Re: Village of Hoffman Estates

Village Green Concessions

Architect's Project Number: 24-002

Addendum #1

1 ELECTRICAL POWER PLAN
E1.00 3/16" = 1'-0"

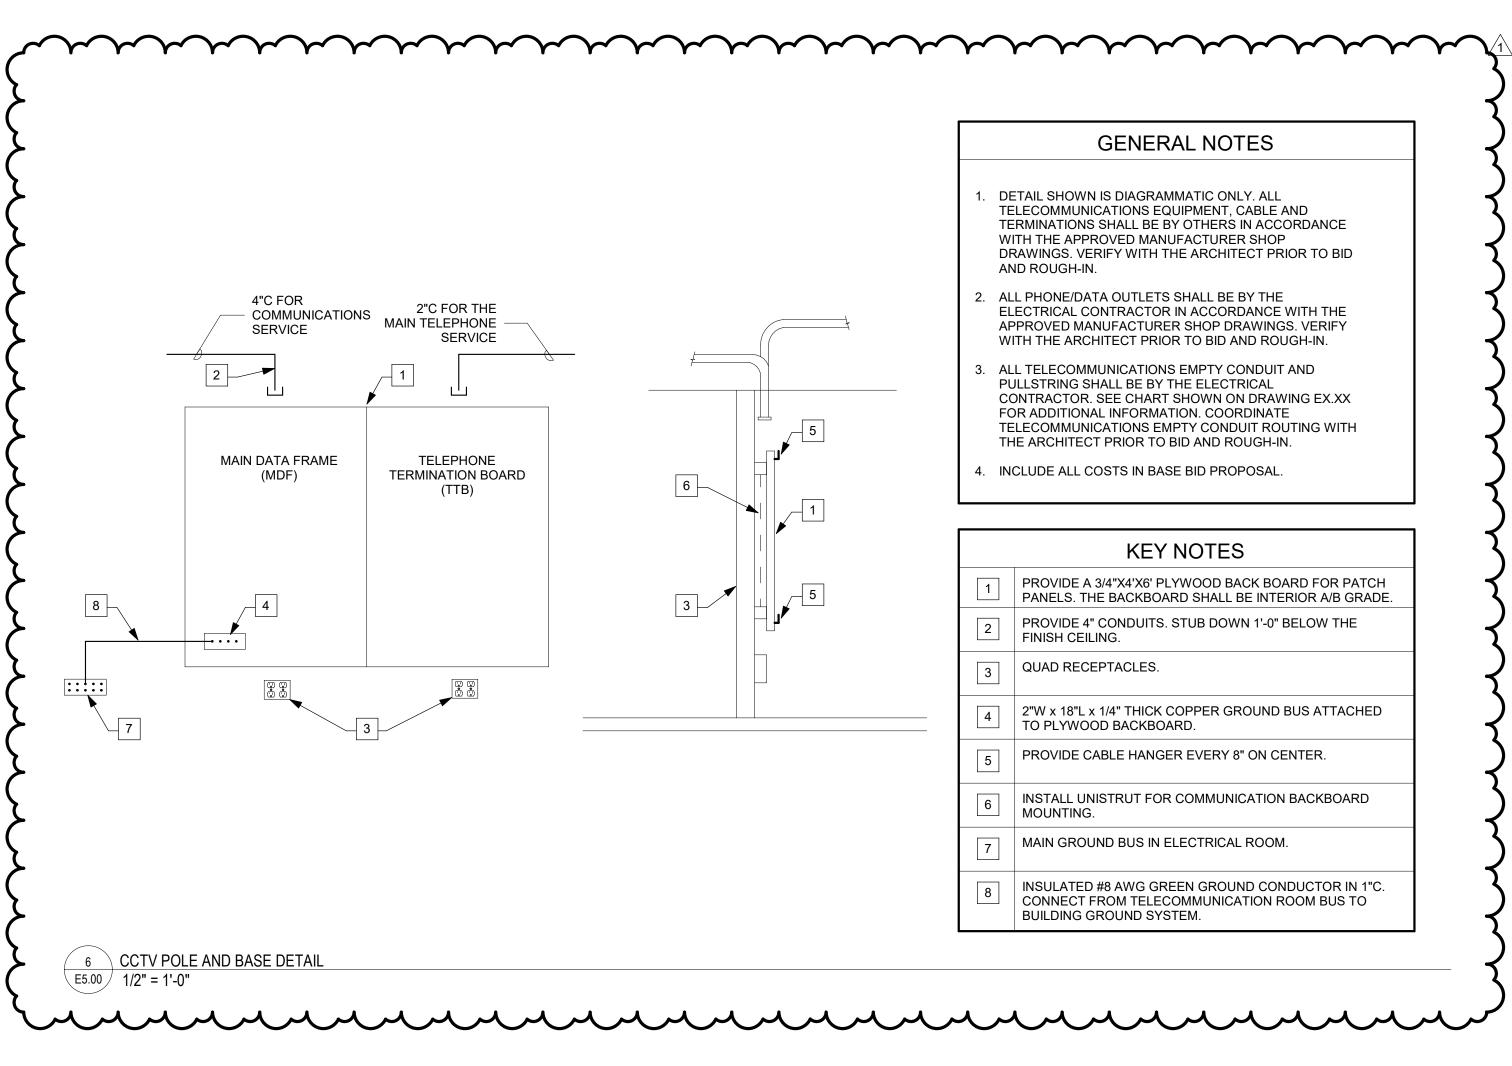
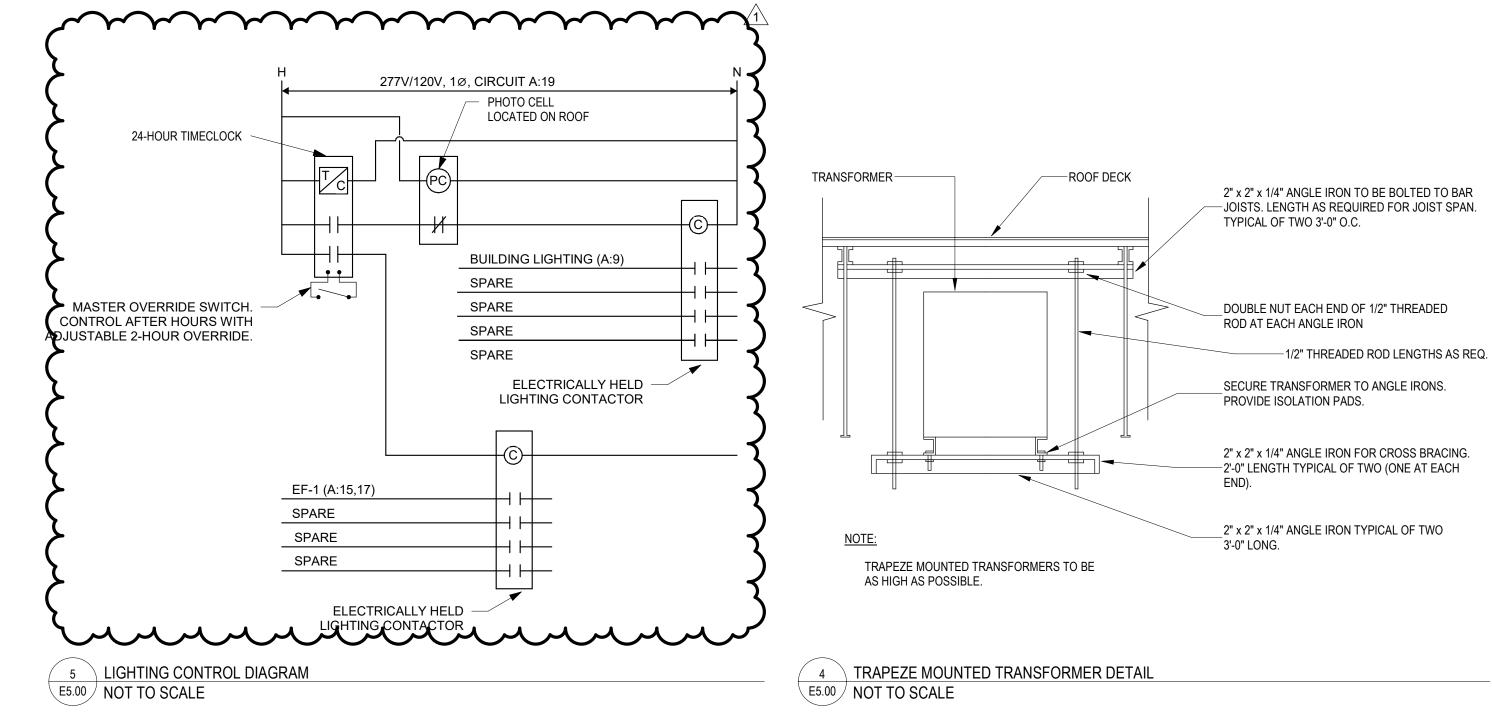
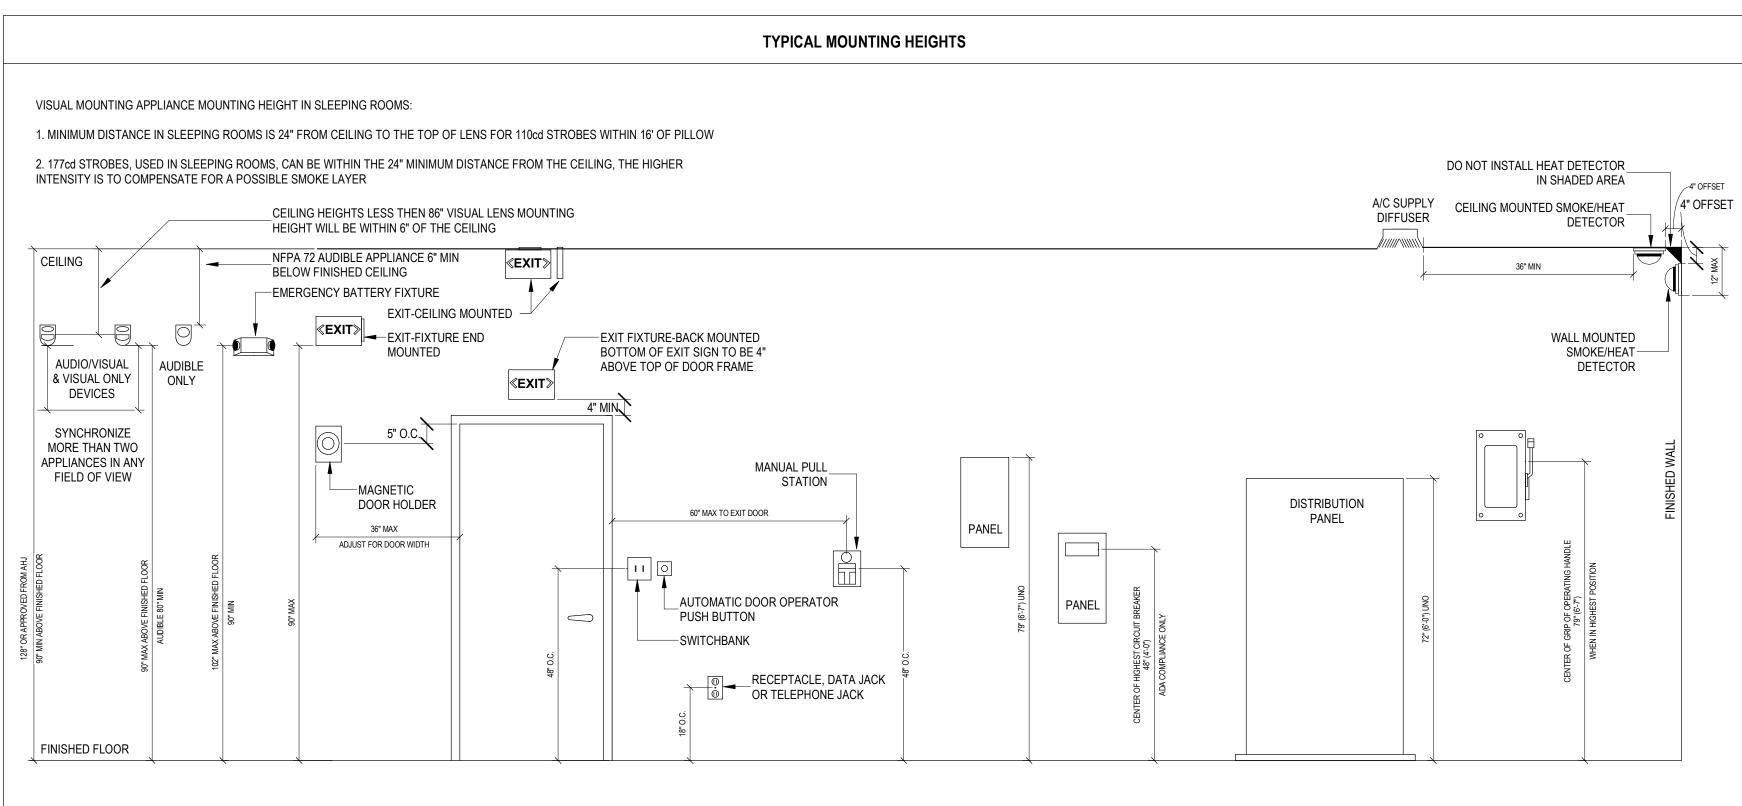
- a. "LED illuminated box wall signage refer to exterior elevation and electrical drawings provide wood blocking as required."
- 11. Drawing E1.00 **ADD** as follows, refer to replacement drawing attached:

- a. Fire alarm panel
 - b. Fire alarm devices
 - c. Callout for telephone backboard
 - d. Location of telecom entrance with note
- 12. Drawing E4.00 **ADD** as follows, refer to replacement drawing attached:

3 EQUIPMENT AND DEVICE MOUNTING DETAIL E5.00 NOT TO SCALE

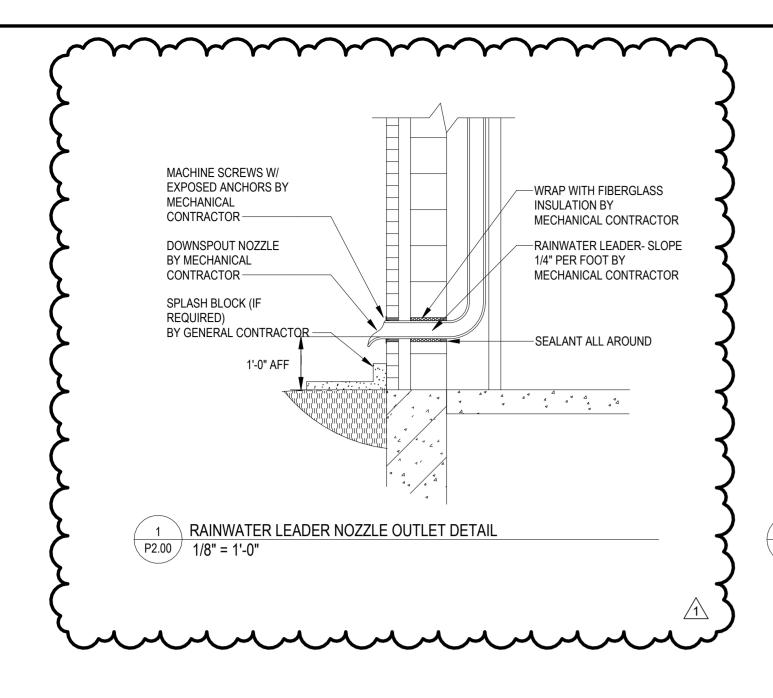
- a. 20A circuit to Panel 'A' for timeclock
- 13. Drawing E5.00 **ADD** as follows, refer to replacement drawing attached.:
 - a. Added circuits to Detail 5

- b. Added Detail 6
- 14. Drawing P2.00 **REVISE** as follows:
 - a. Detail 1 revised refer to replacement drawing attached.
- 15. Drawing FP0.00 **REVISE** as follows:

WATER SERVICE LINE EXTENSION DETAIL √FP0.00/ NO SCALE

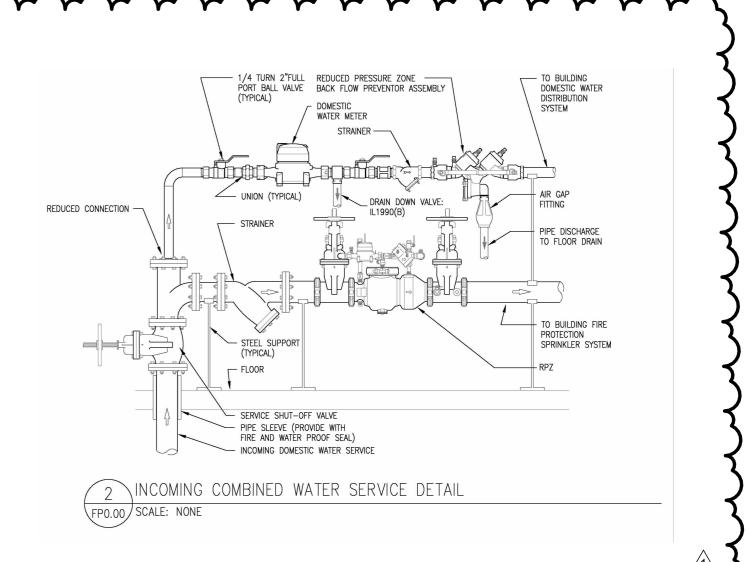
- a. Detail 2 has been revised refer to replacement drawing attached.

- 19. QUESTION: Normally per Illinois Plumbing codes there is only one water service that comes into a building, it splits after it comes up out of the floor. One way it goes to fire protection and the other way it goes to the domestic water service. It is highly unusual to use a wall post indicator in the fashion shown in Detail 2 on FP0.00, especially if this is a combined water service. There is a shutoff valve in the 6" underground supply and the shut off valve for the fire sprinkler system will be the downstream valve of the backflow preventor. Please confirm the control valve and wall post indicator shown in Detail 2 on FP0.00 can be eliminated.

20. QUESTION: Please confirm the main drain can be a 2" size as per NFPA- 13 2019 edition, section 16.10.4.2 and Table 16.10.4.2 in lieu of the $2\frac{1}{2}$ " size shown.

21. QUESTION: Please confirm the intent of the details in Detail 2/ FP0.00 is to provide a combination inspectors test and drain valve at the wet system riser.

ANSWER: Intent is to provide a combined service into the building and split into fire protection and domestic water service after penetrating through floor. This is called out in keynotes on sheets P1.00 & FP1.00. Detail 1/P2.00 & Detail 2/FP0.00 have been removed as they do not depict accurate information for this project. Control valve and wall post indicator can be eliminated. New detail included for combined service include (New 2/FP0.00).

ANSWER: 2" main drain is confirmed. Detail 2/FP0.00 has been replaced.

ANSWER: Detail 2/FP0.00 has been replaced. However, the intent is indeed that there is a test port for the riser.
